STAFF REPORT: FEBRUARY 12, 2025 MEETING

APPLICATION NUMBER: HDC2024-00661

ADDRESS: 258 ELIOT

SCOPE: REPLACE WOOD WINDOWS WITH VINYL WINDOWS (WORK COMPLETED WITHOUT APPROVAL)

Façade. The windows in the dormers are vinyl replacement units. Staff photo.

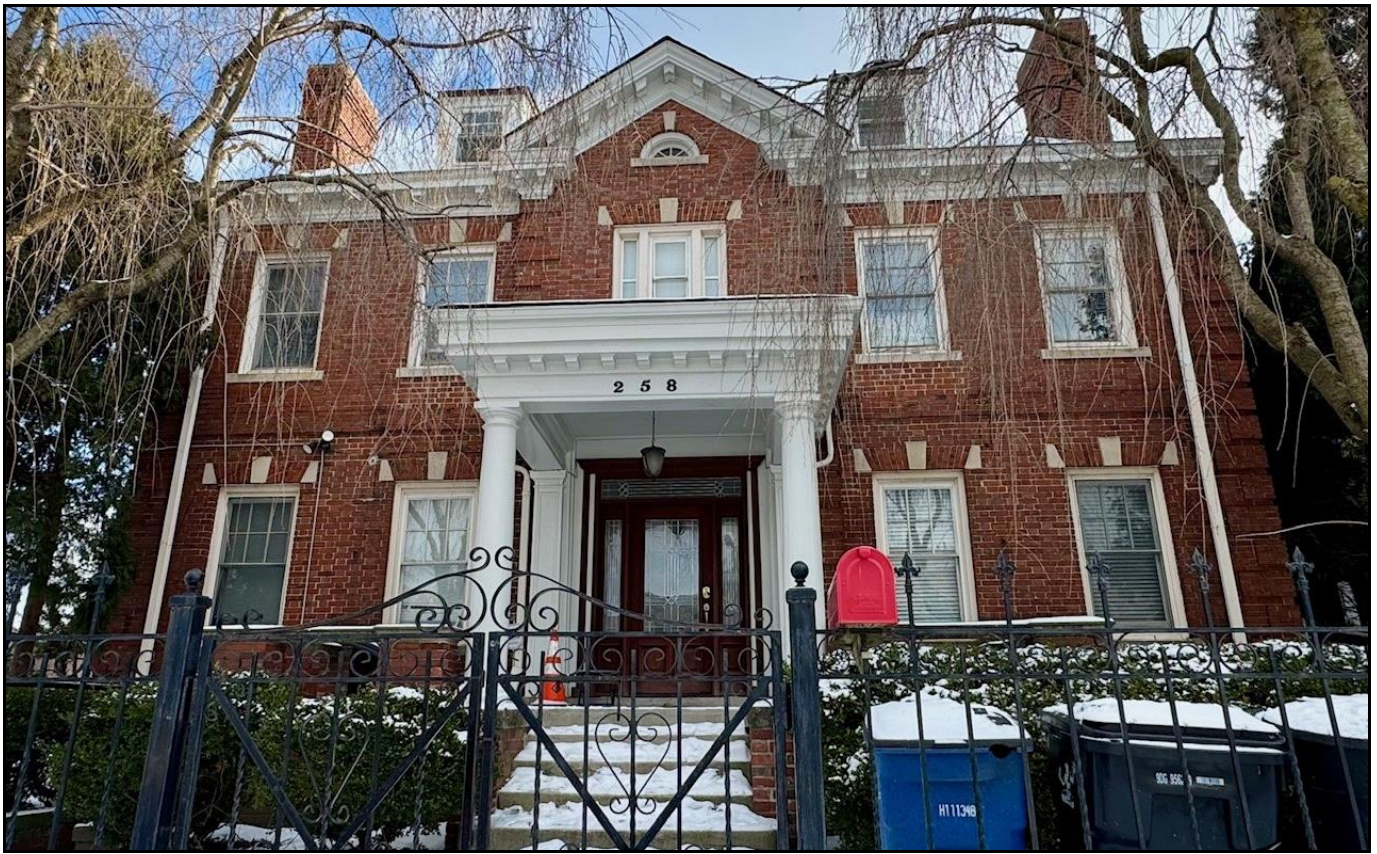
- It is staff's opinion, the dormers are character-defining features due to their design, placement, visibility and function and replacement windows must be compatible with the appearance and character of the building.

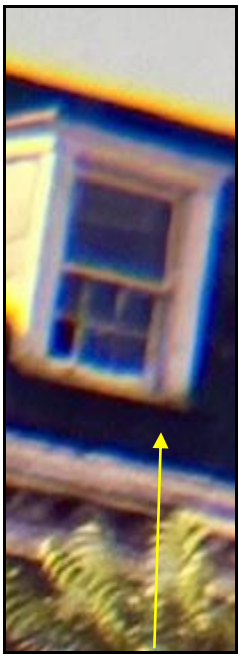
- The installed white vinyl windows with between the glass grids, offer a bright white, flat appearance. Additionally, the forward placement of the window sash within the dormers creates an additional flat surface.

This current view of a front-facing dormer clearly shows how the dimensionality of the window and window opening were lost due to the between the glass grids and forward placement of the window sash within the wood-framed dormer. Staff photo, January 24, 2025.

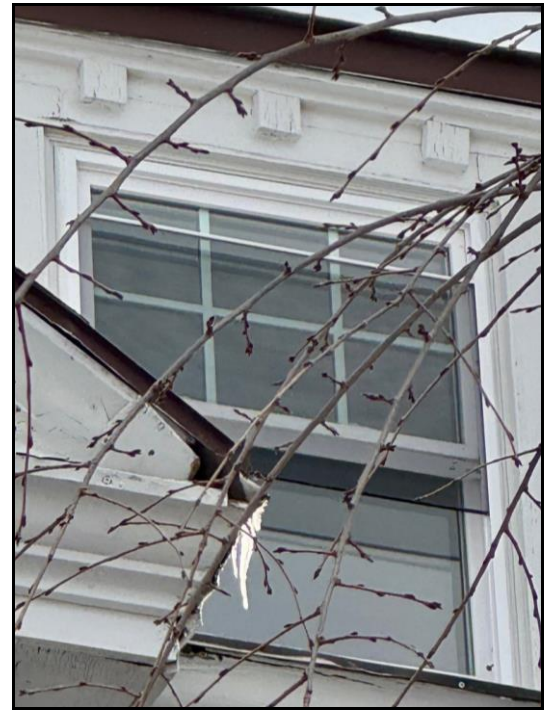
- Placement – Historically, windows are recessed within walls to differing depths, depending on the exterior wall material. Windows within brick clad walls, sit deeply within the window opening, but even with wood framed/clad walls, windows are still recessed from exterior walls. This creates a differential of wall planes, so each element (wall and window) has equal visual impact on an elevation.
